GROUP	NUMBER		
Body	20-BD-016H		
DATE	MODEL(S)		
June, 2020	Santa Fe (TM) Palisade (LX2)

SUBJECT: SECOND ROW SEAT TRACK NOISE REPAIR

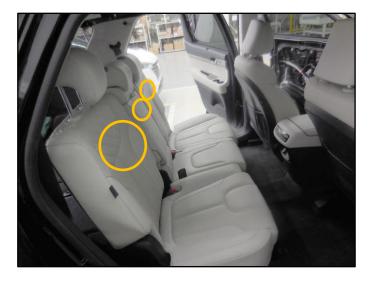
1. Tap the upper portion of the rear seat back 10+ times to inspect for noise.

Perform this inspection on all rear seat backs.

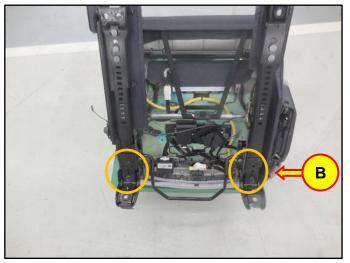
If noise is heard from a rear seat back, carefully remove the affected rear seat (A) using the applicable vehicle shop manual section below:

Do not damage the seat or vehicle components during removal.

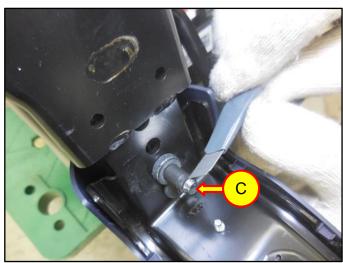
3. Place the rear seat on a workbench, and locate the track location pins (B).

4. Use a utility knife to cut the existing location pin tubes (C).

5. Remove and discard both location pin tubes.
